CERTIFICATE OF APPROPRIATENESS

Property: 714 Woodland Street, lot 3, tract 4A, block 36, Woodland Heights Subdivision. The property includes a historic 2,491 square foot, one and half story wood frame single-family residence situated on a 7,500 square foot (75' x 100') interior lot.

Proposal: Alteration – Replace the existing porch shed roof with a new shed roof to match the existing roof and replace four non-original square wood porch columns with four 8 1/2" square wood columns with 10" square wood bases. Install wood handrails and guardrails. Install two new wood brackets on the front and rear gable dormers and five brackets on the side gables to match the original missing brackets. Install a brick facing on the existing concrete porch and concrete steps.

Recommendation: Partial Approval:

NORTH ELEVATION – FRONT FACING WOODLAND STREET

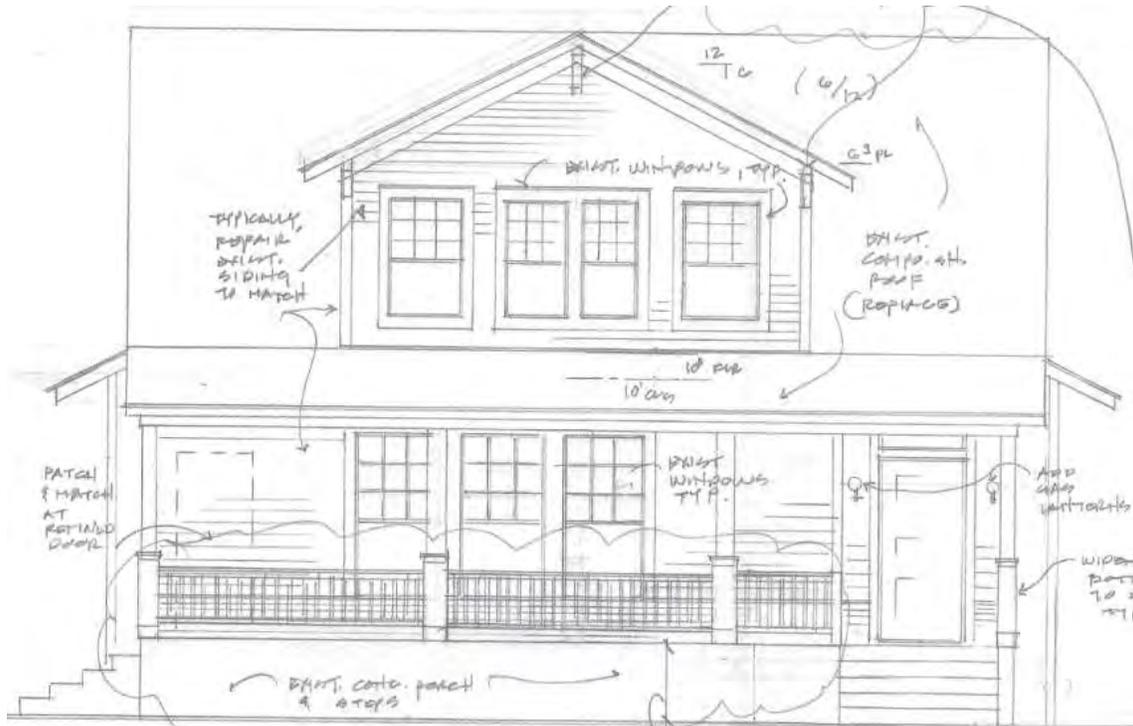
| <input type="checkbox"/> | <input checked="" type="checkbox"/> | <input type="checkbox"/> | (3) | The proposed activity must recognize the building, structure, object or site as a product of its own time and avoid alterations that seek to create an earlier or later appearance; <i>The application of the brick facing to the existing concrete porch and steps creates a false sense of history by introducing an architectural feature that has never been present on the residence.</i> | |
| <input type="checkbox"/> | <input checked="" type="checkbox"/> | <input type="checkbox"/> | (4) | The proposed activity must preserve the distinguishing qualities or character of the building, structure, object or site and its environment; <i>Brick porches and brick facings on porch decks and steps are not typical of contributing residence in the district. The typical condition found in the district is either wood porch decks with either wood or concrete steps or a concrete porch deck with concrete steps.</i> | |

Front Elevation: The residence features three 9-over-1 wood sash windows and a wood paneled entry doors with a transom; the windows and door will be retained. The full width front porch features a concrete porch deck with concrete steps; a brick facing will be applied to the concrete porch deck and concrete steps. The porch features four square wood columns that will be replaced with four wood columns with wood bases. The front dormer features a decorative wood bracket; two new wood decorative brackets will be installed on the dormer.

Deny: The application of the brick facing to the existing concrete porch deck and concrete steps.

Denied: Application of brick facing to the existing concrete porch deck and concrete steps.

FRONT PORCH COLUMN DETAIL

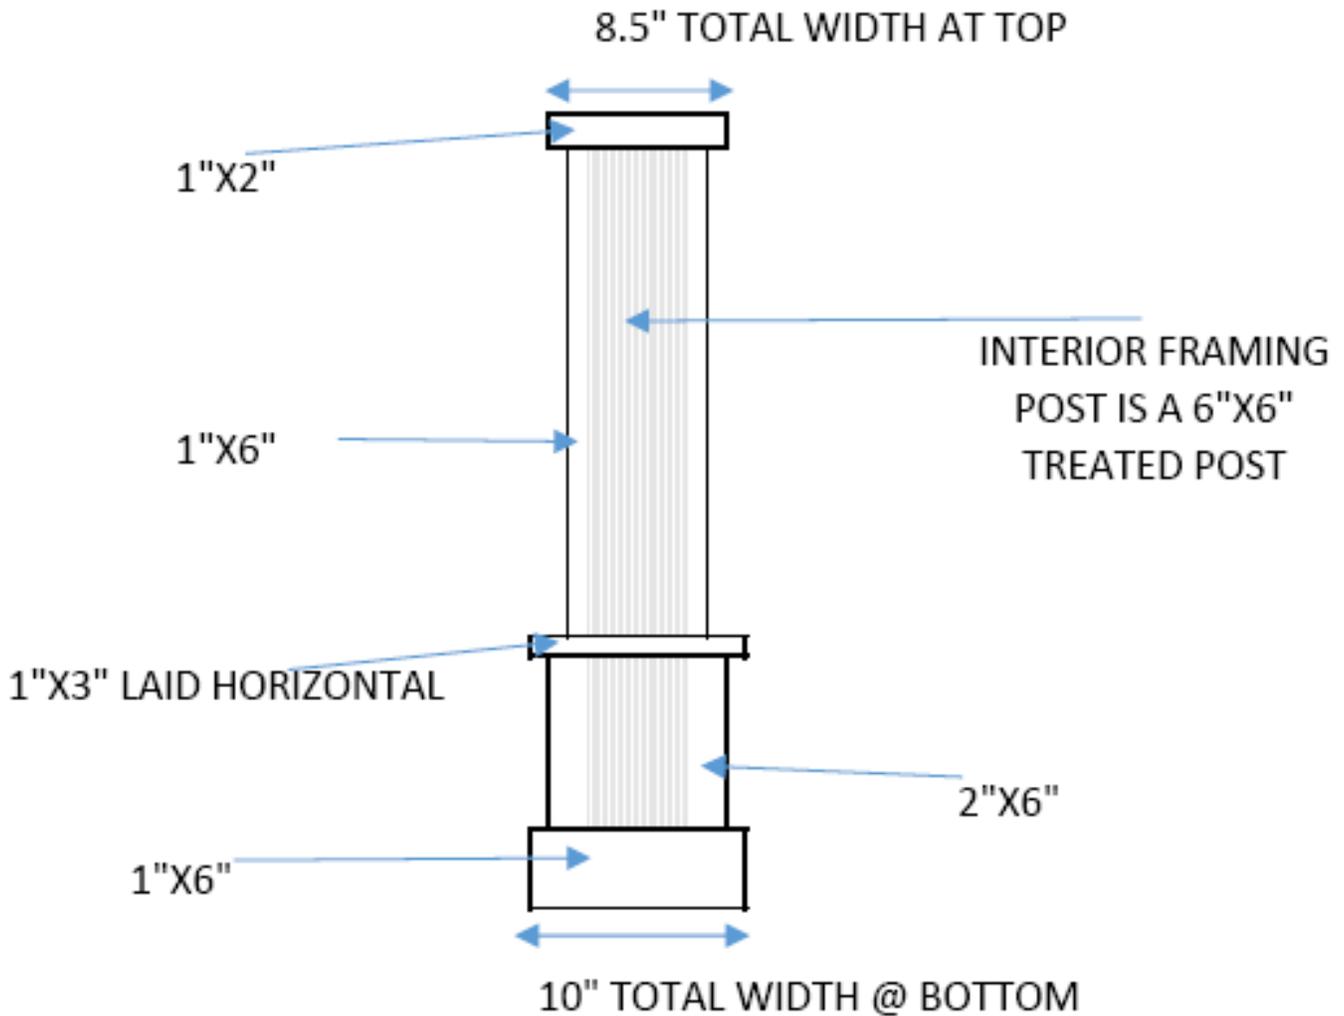
Exterior Materials: The front porch features a concrete porch deck, concrete steps, and wood square columns. The four wood square columns will be replaced with four 8 ½" square columns with 10" wood square bases. A brick facing will be applied to the concrete porch deck and concrete steps. Wood decorative brackets will be installed on the front and rear dormers and on the side gables. The residence features decorative wood brackets on the front and rear dormers; the side gables are missing the brackets but there is evidence that brackets were originally present.

Approve: The replacement of the shed roof with a new shed roof that matches the existing, replacement of the four existing square porch columns with four square 8 1/2" columns with 10" square bases, and installation of wood brackets on the front and rear dormers and side gables.

Approved: The replacement of the existing shed roof with a new shed roof to match the existing, replacement of the square columns with four 8 1/2" columns with 10" square wood bases, and installation of wood brackets on the front and rear dormers and side gables.

WOOD BRACKET DETAIL

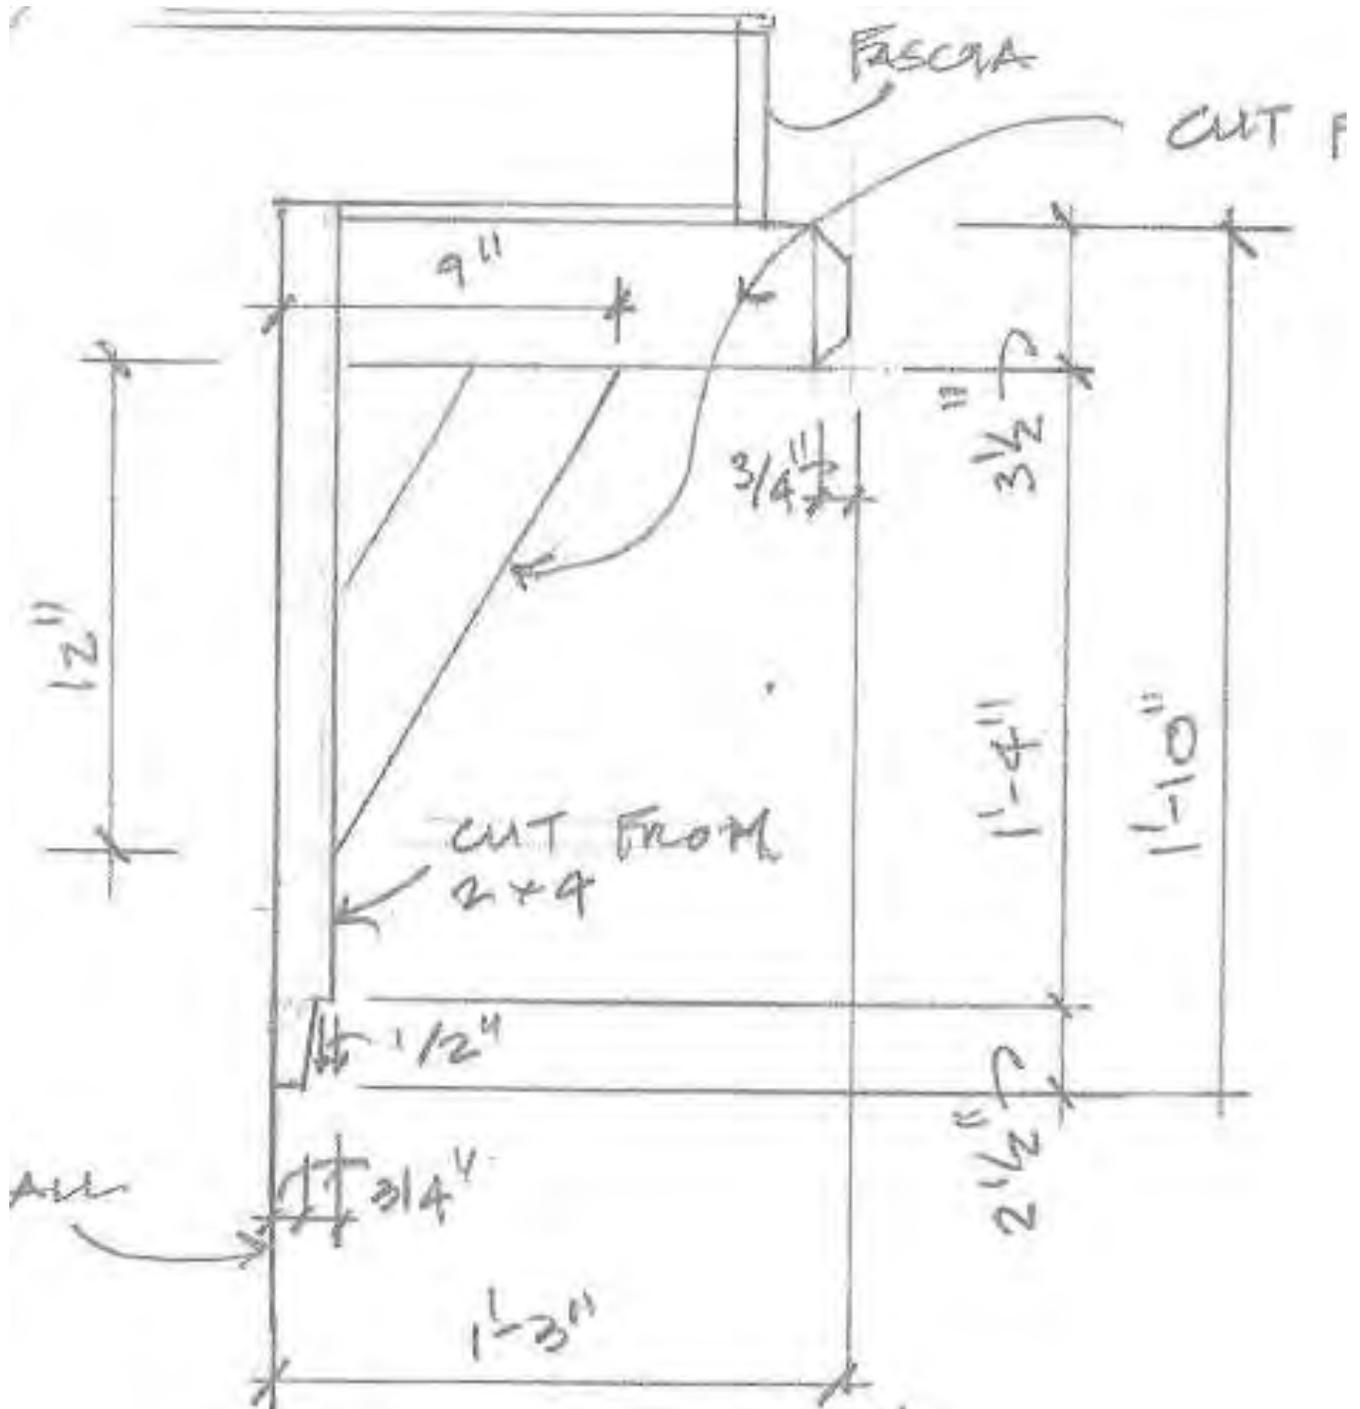
Side Elevation: Five wood decorative brackets will be installed under the side gable eaves.
(East)

Side Elevation: Five decorative brackets will be installed under the side gable eaves.
(West)

Rear Elevation: The rear dormer features a wood decorative bracket; two new wood decorative brackets will be installed on the dormer.
(South)
